# City of Cambridge

**RE: File No. 11536 – Danehy Park Field 4 Field and Track Improvements - Addendum No. 1**

- 1. Questions and Answers**
- 2. Justification Memo (Attached)**
- 3. Pre-Bid sign in sheet (Attached)**
- 4. Changes to the Drawings (Attached)**

Electrical Cabinet

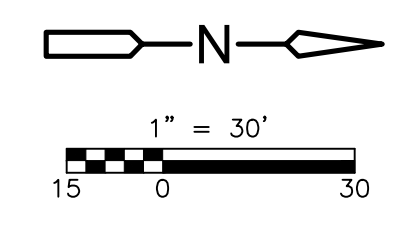
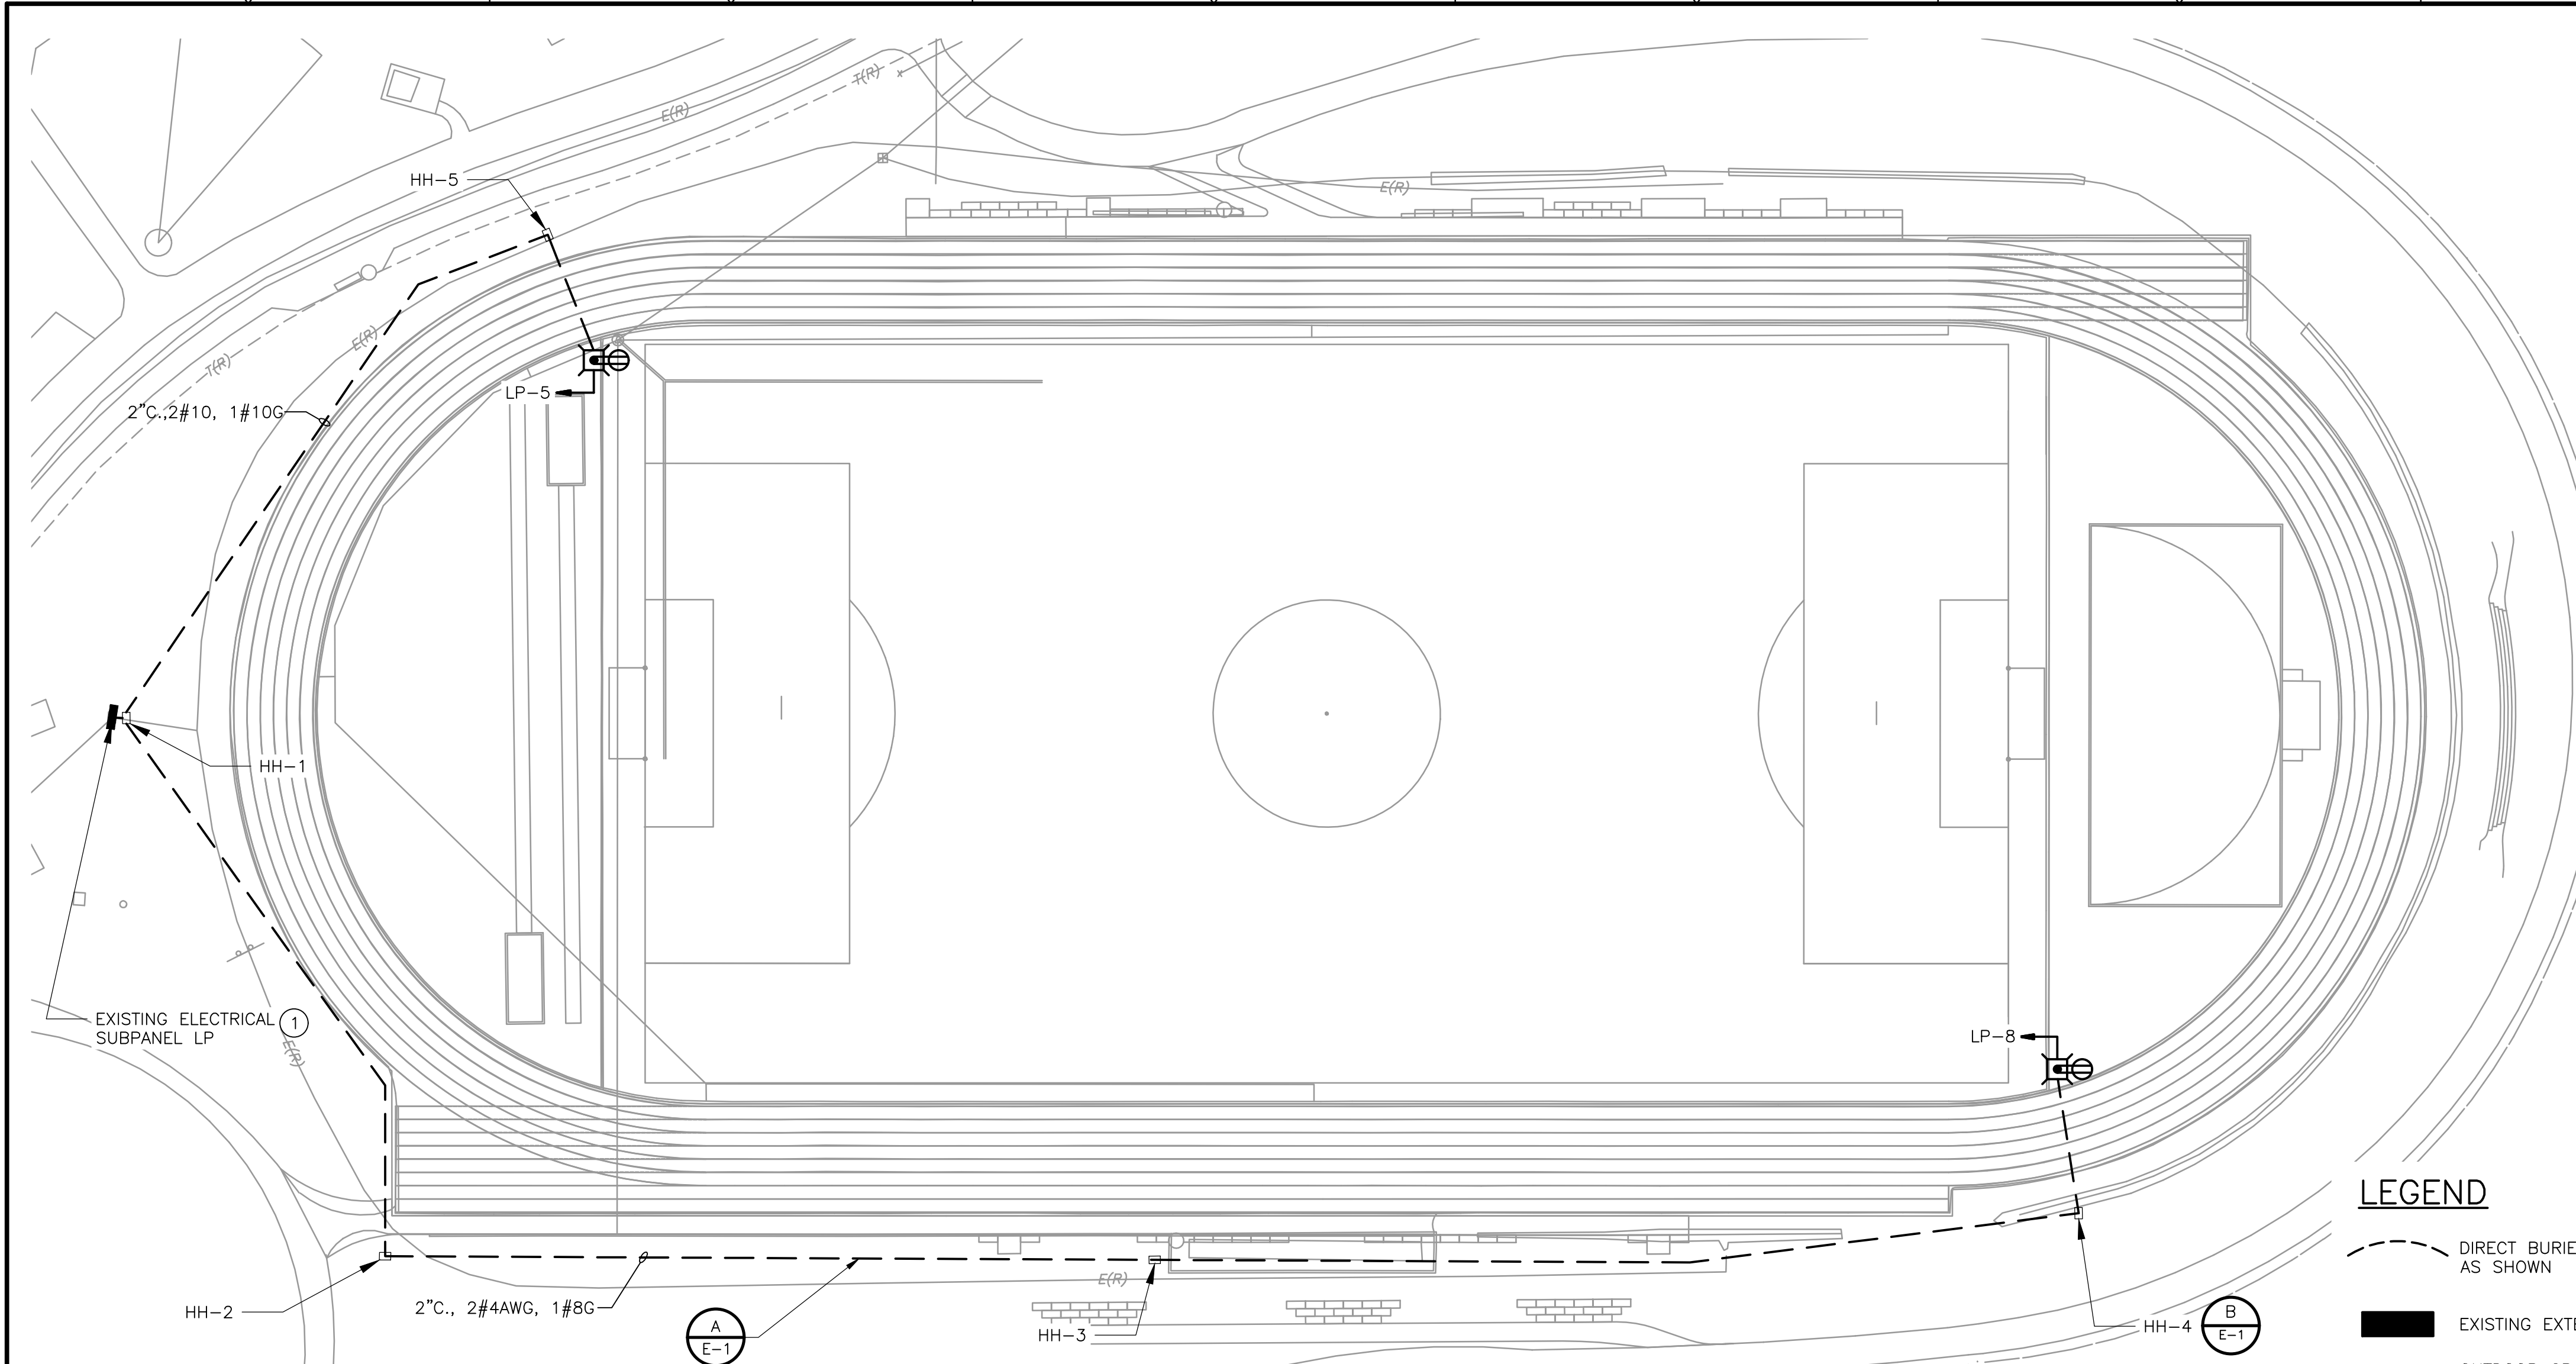
**Question 3: Are there any images of inside the electrical cabinet we are connecting to?**

**Answer: See attached images below.**

**ELECTRICAL HANDHOLE DETAIL**  
N.T.S.

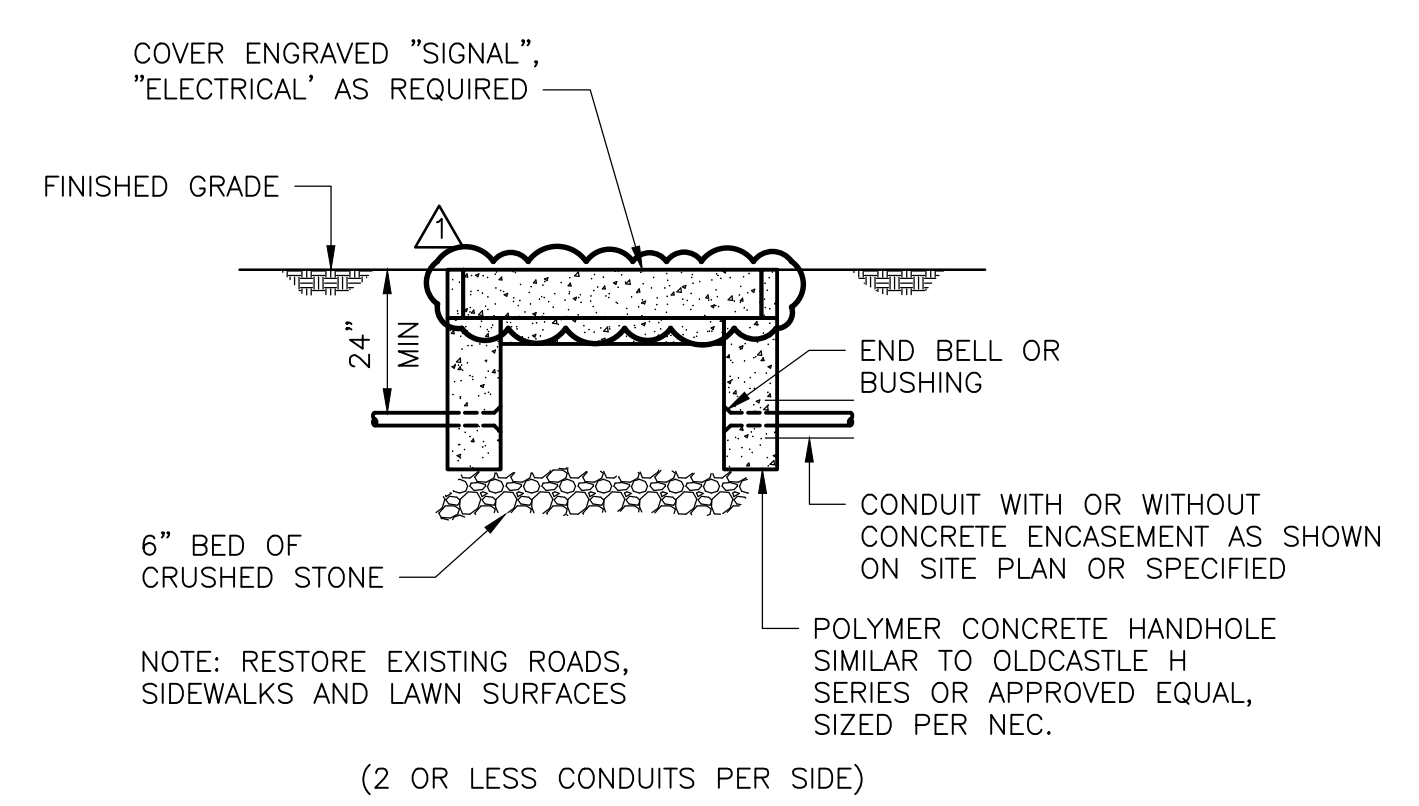
2. **REPLACE sheet E-1-ELECTRICAL SITE PLAN with the attached plan with the following modifications:**
  - a. **Detail A- Change gravel backfill to in-situ material.**
  - b. **Detail B – Modification of electrical handhole detail.**

IRRIGATION REFERENCE PLAN-1  
 SHEET NO. R-1

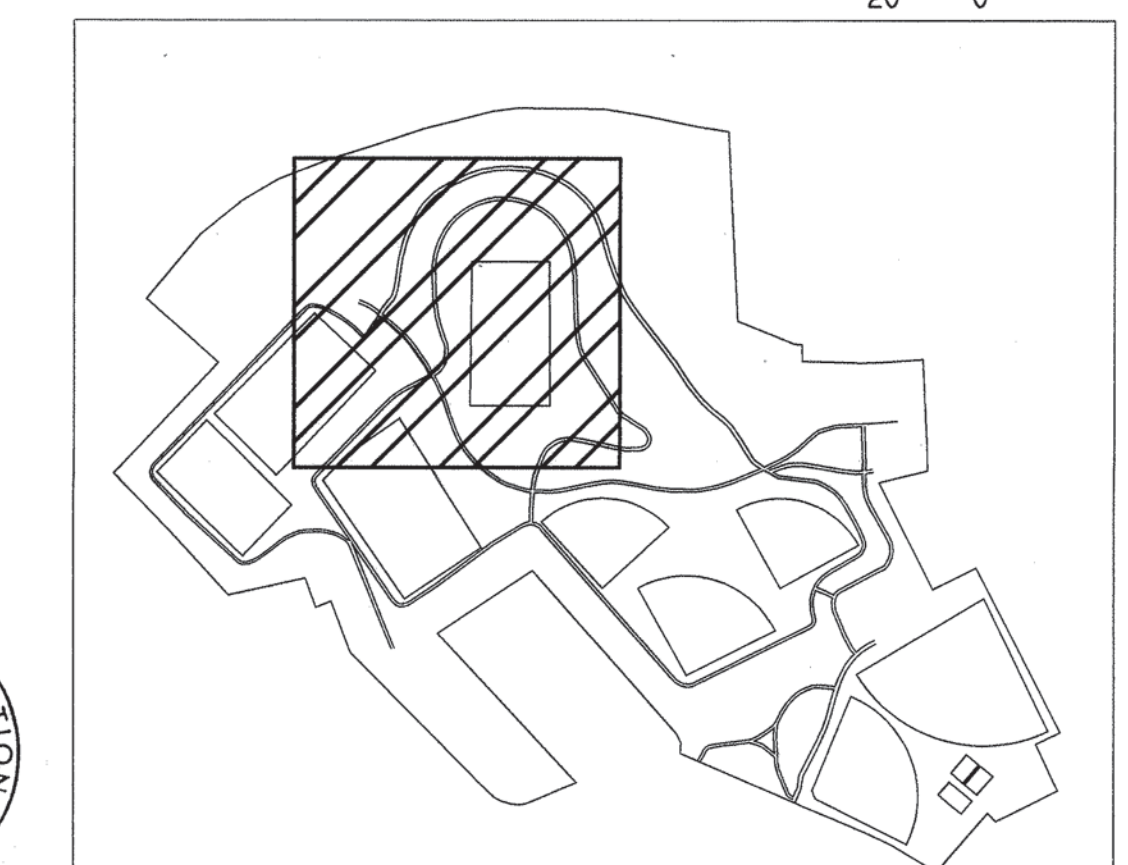
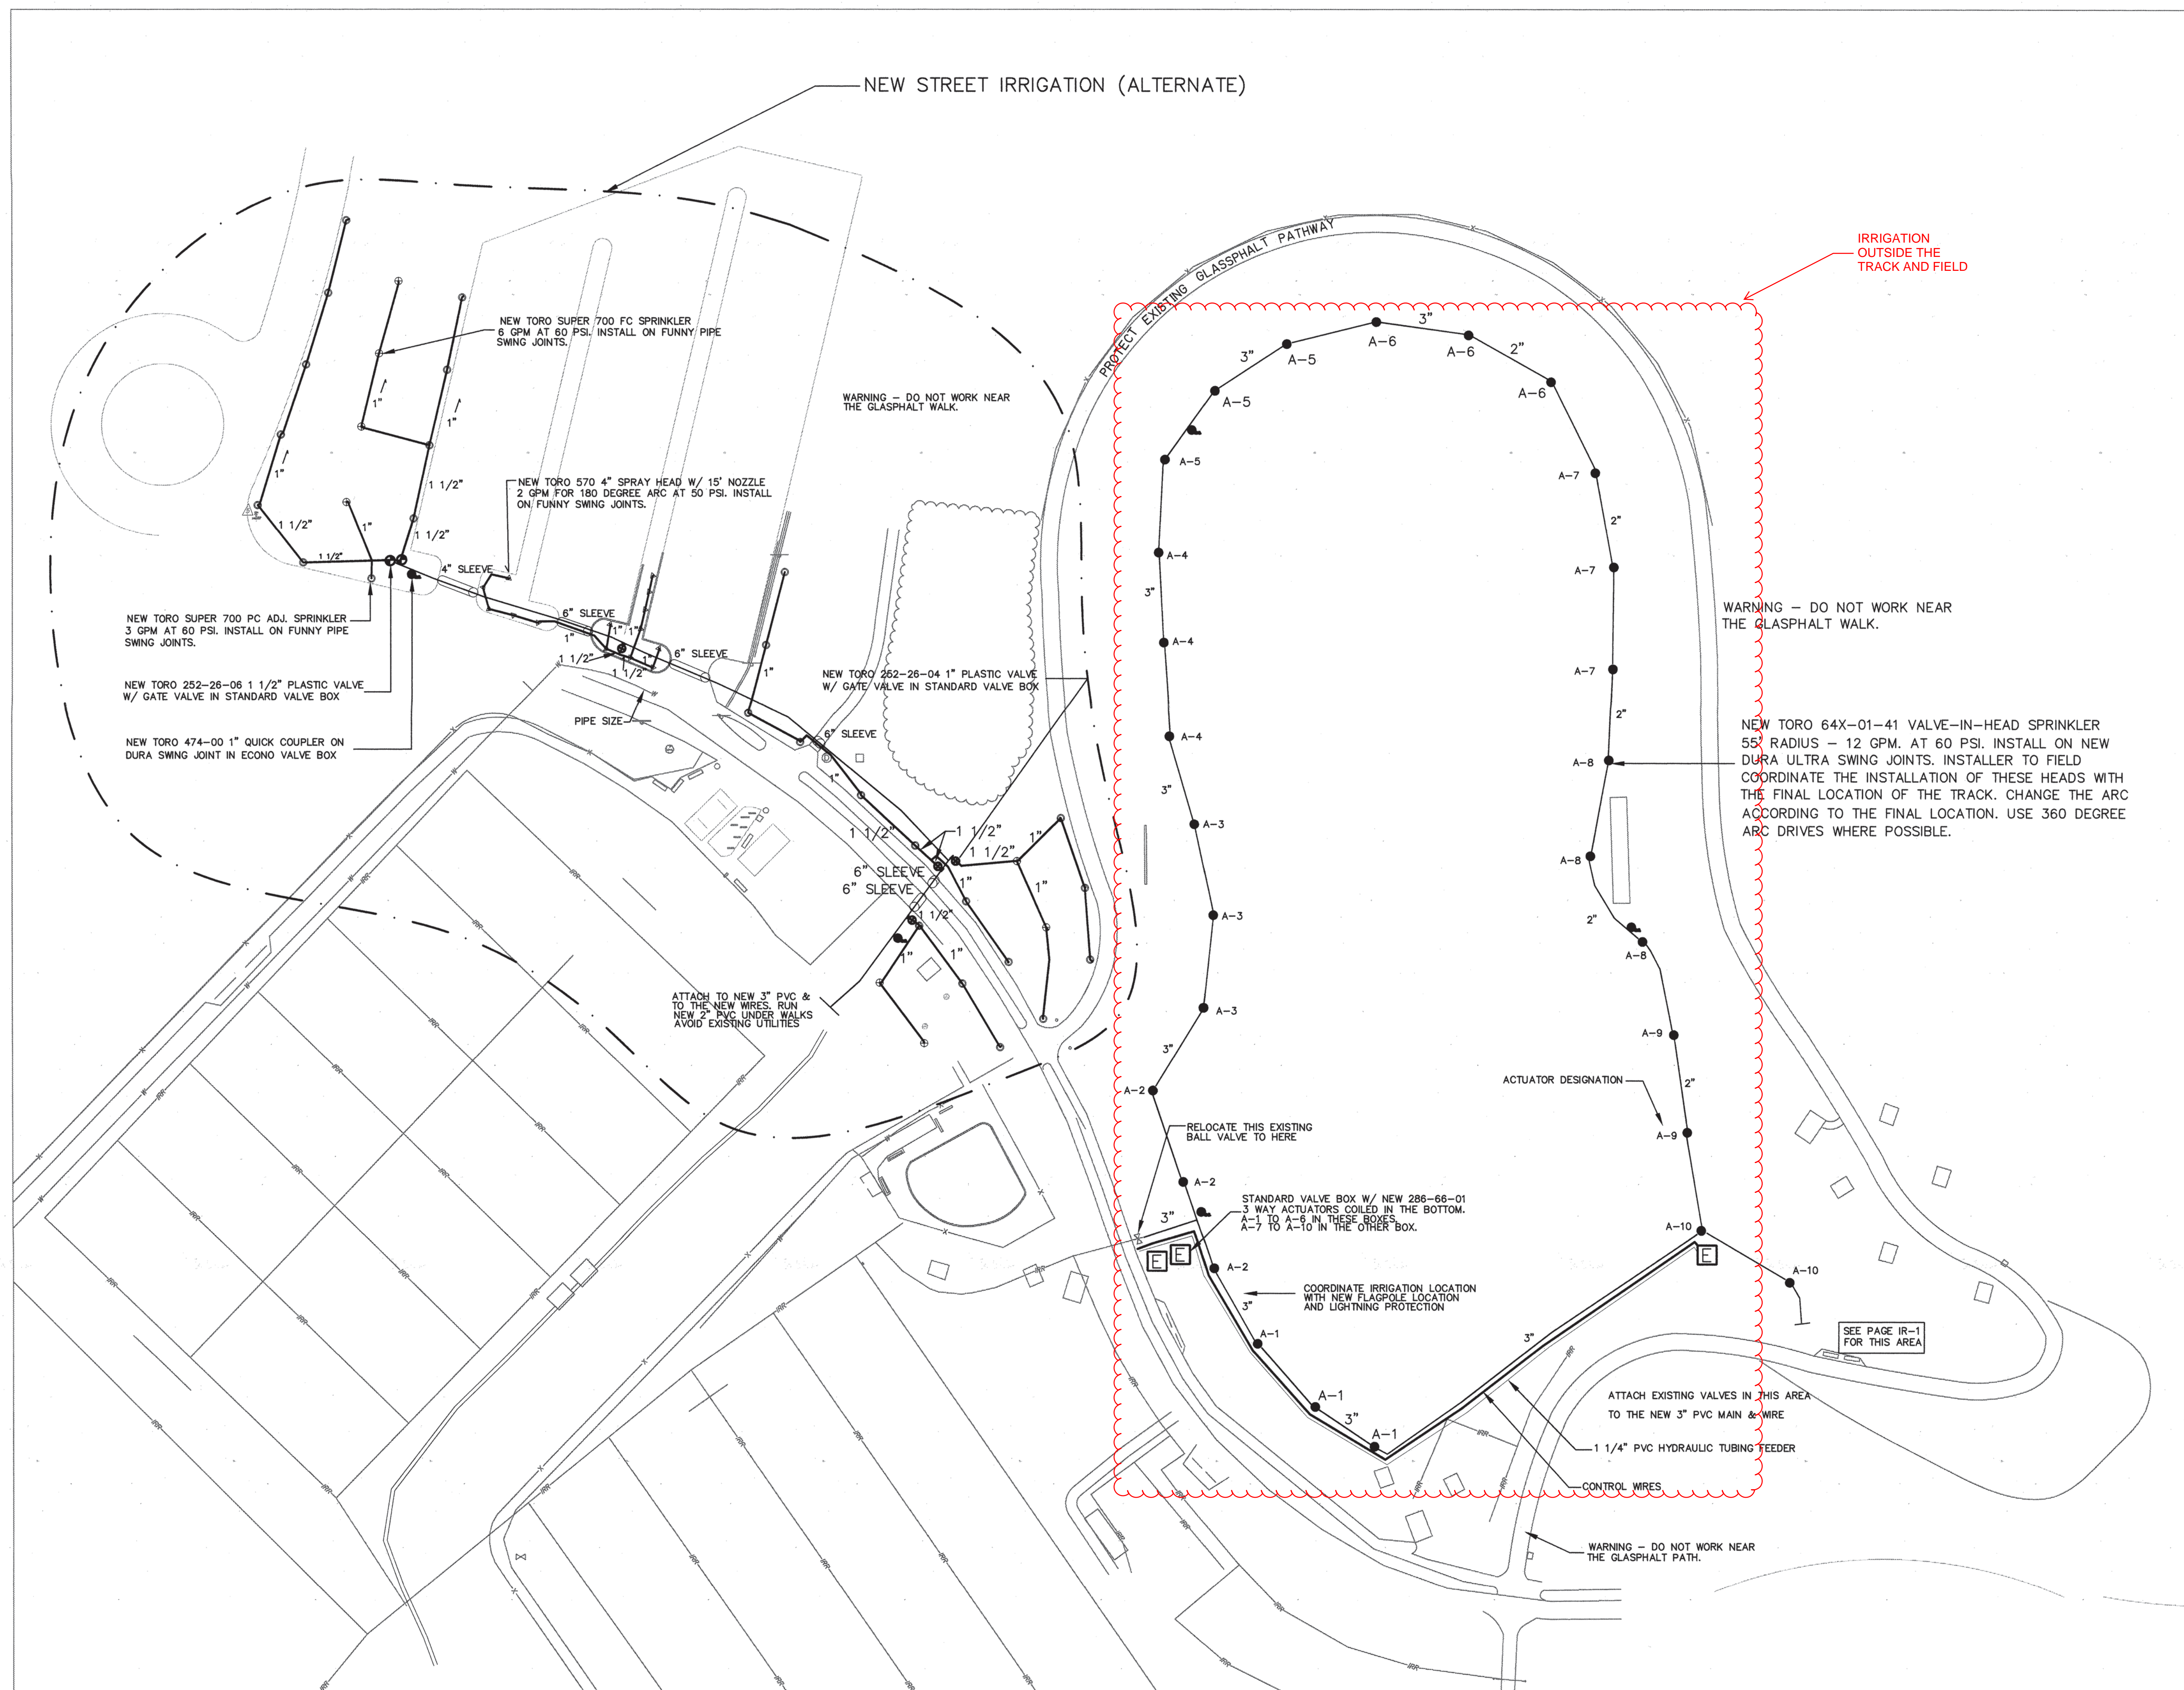
**Question 2: Is there any irrigation in the work area that needs to be addressed?**

3. **ADD two attached drawings “R-1” and R-2” for exiting irrigation system reference.**

**Answer: See reference drawings attached that identify irrigation in the area.**
